H11701

DESCRIPTIVE REPORT

General Locality Chatham Strait

Sublocality Mitchell Bay and Kanalku Bay

Figure 1 H11701 Area Surveyed

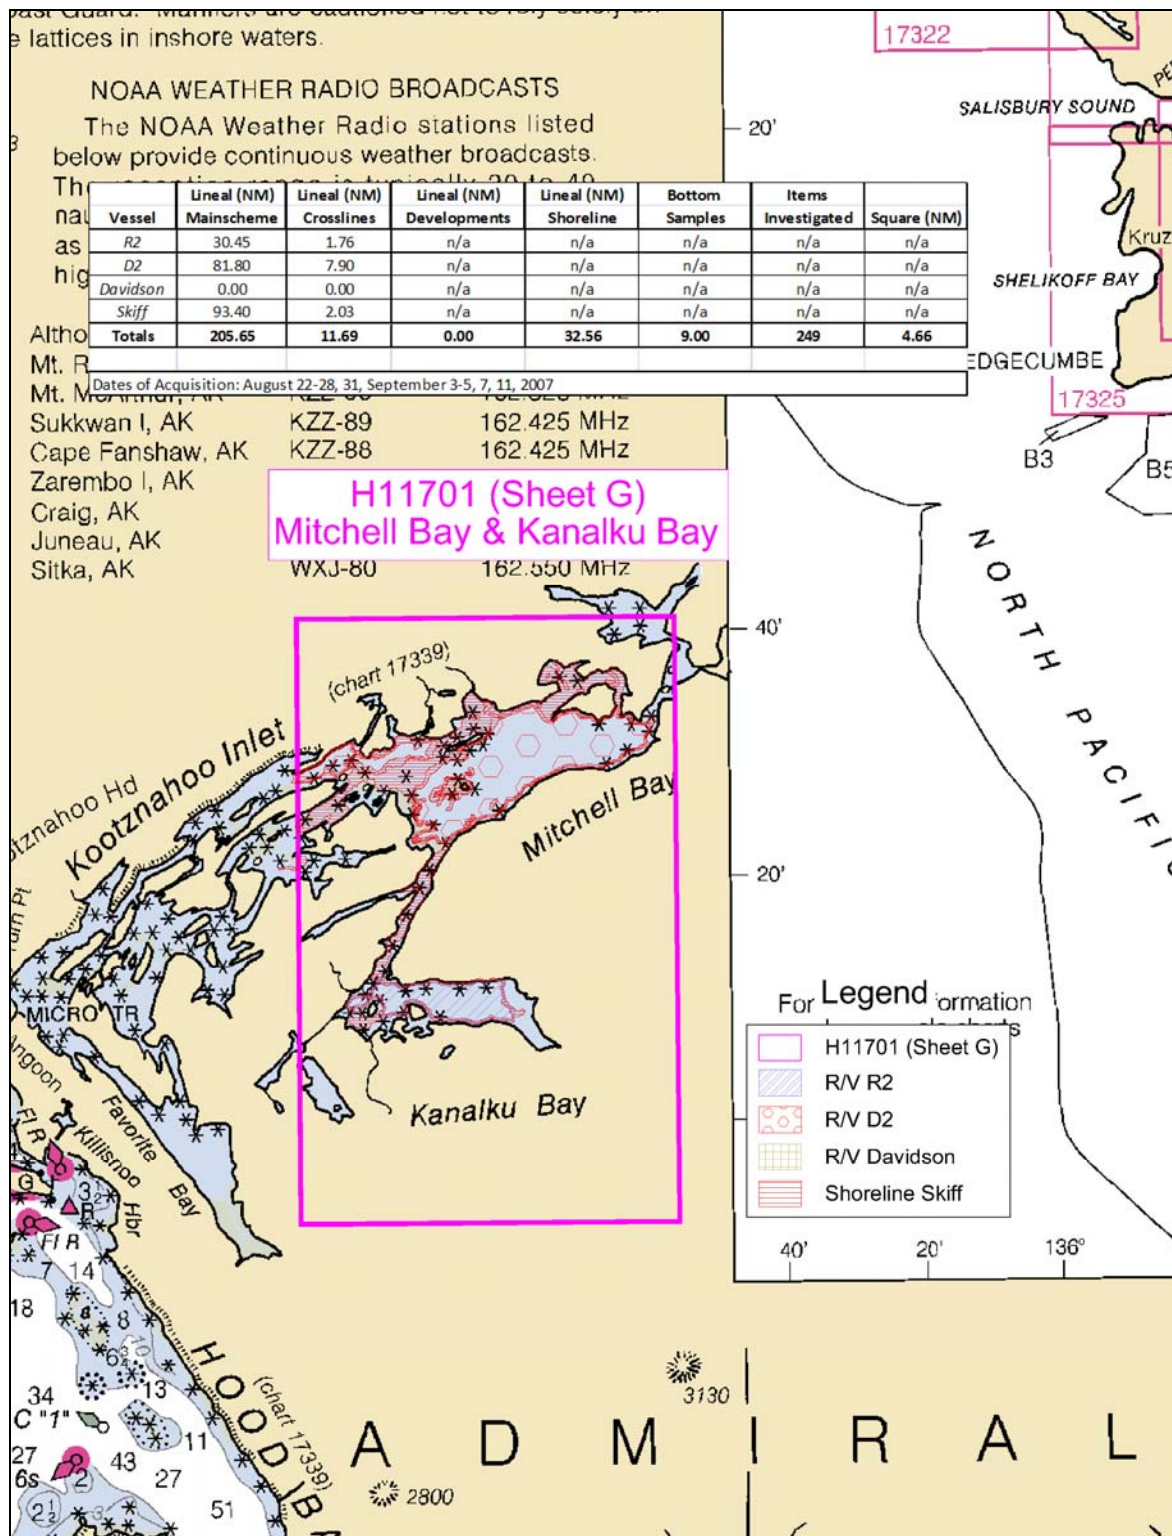
H11701 (Sheet G) is bound by the coordinates listed below, which encompass the area of Mitchell Bay and Kanalku Bay.

- ¹ Do not concur. The bounding box of the survey has the following corners:
SW – 57-29-30.27N, 134-29-42.20W NE – 57-33-59.04N, 134-21-05.37W
- ² Filed with project records.

Figure 3 H11701 Uncertainty DTM

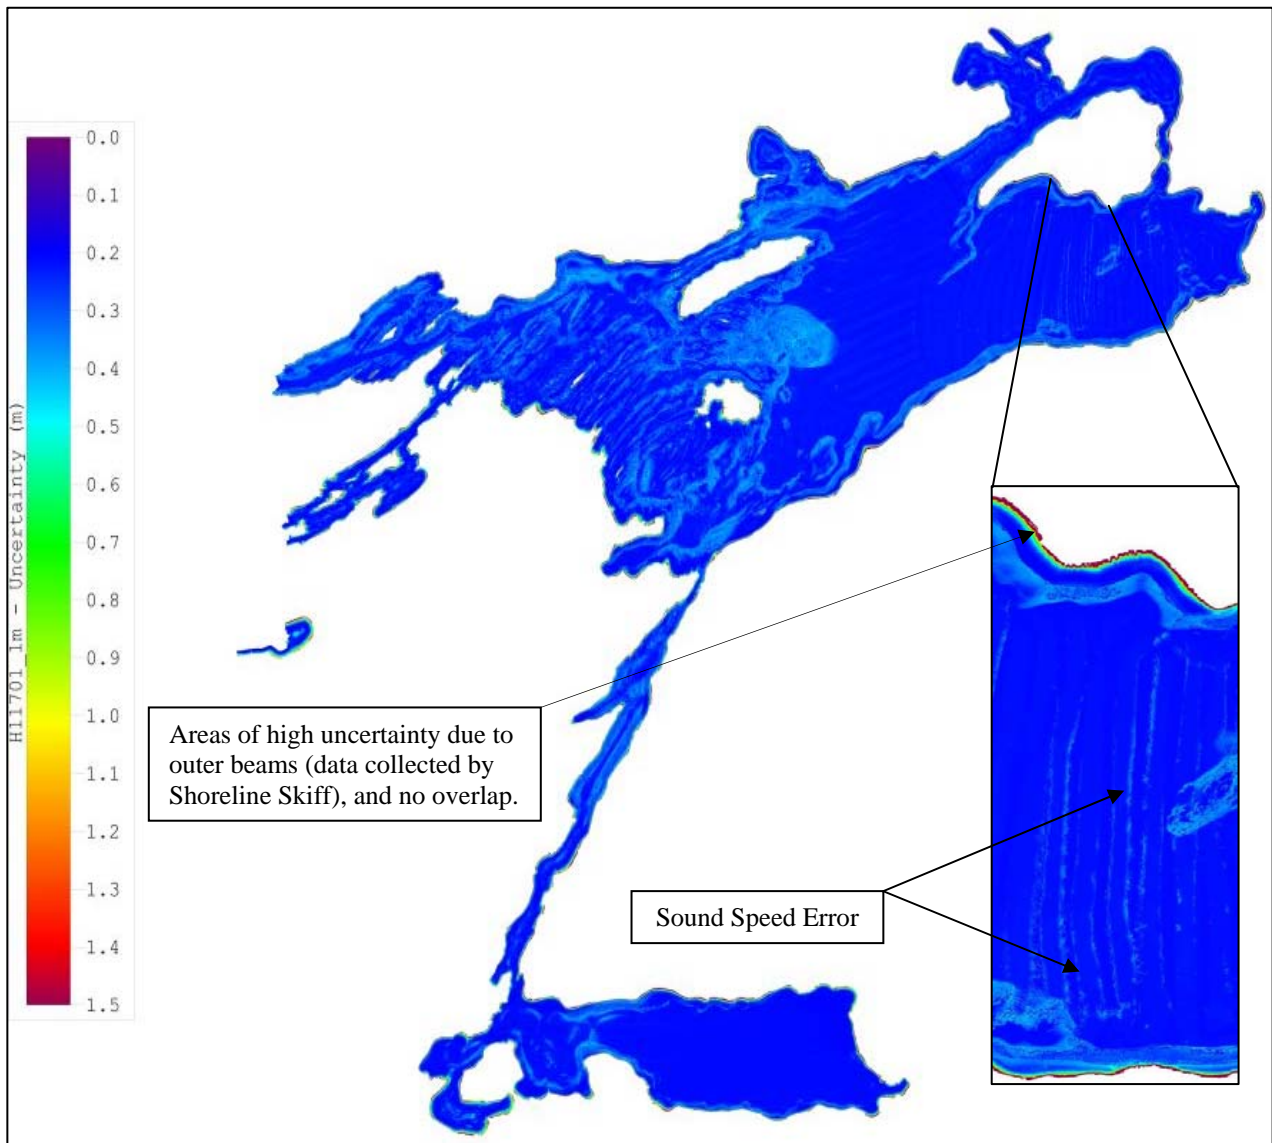
The majority of H11701 had an uncertainty of approximately 0.20 to 0.40 meters. An exception to this is found in the nearshore areas in water depths of 1 to 2 meters where the uncertainty values ranged from 1.5 meters and higher. This was due to sparse data density of the outer beams, and from having no overlap. No uncertainty values were greater than the IHO level Order 1.⁴

- ³ Concur.
- ⁴ Concur with clarification. During the Survey Acceptance Review, the data was found to be outside IHO Order 1 specifications. However, all the data from survey H11701 was inspected and deemed sufficient for charting despite having uncertainties that do not meet specifications.

Figure 4 H11701 Survey Junctions

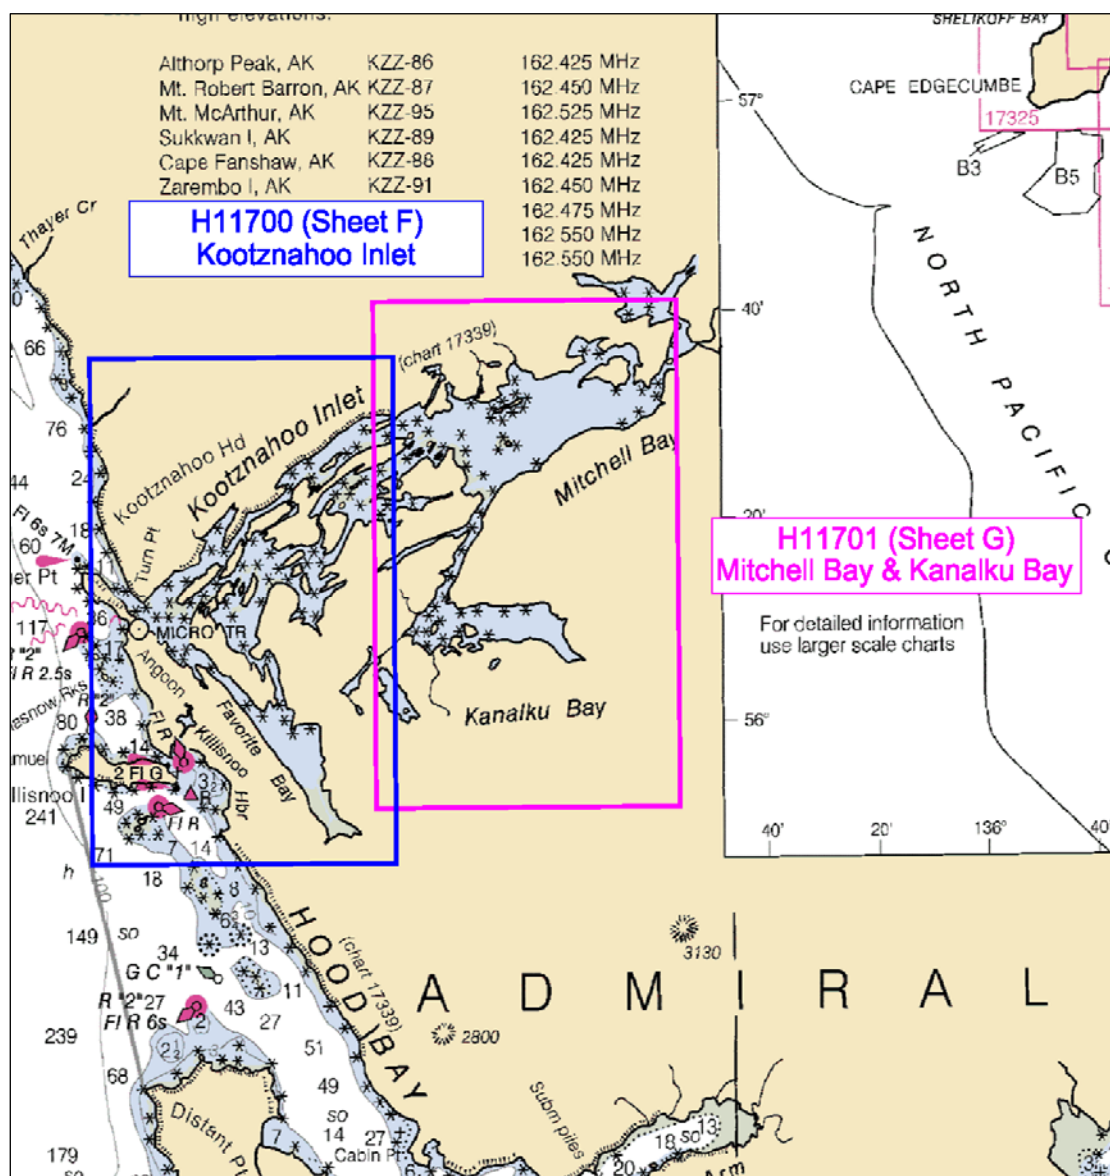
The surveys are in agreement along their common borders. The agreement was noted in the field using the CARIS CUBE surfaces during subset cleaning. The conformity is also apparent in the final combined BASE surfaces.⁵

- ⁵ Concur.
- ⁶ Concur.
- ⁷ Concur.
- ⁸ Filed with project records.
- ⁹ Concur with clarification. The 10m and 15m BASE surfaces were not submitted due to the depth range of this survey. A 5m combined surface was created during the Survey Acceptance Review and was the basis of compilation. See Survey Acceptance Review Checklist filed with hydrographic records.
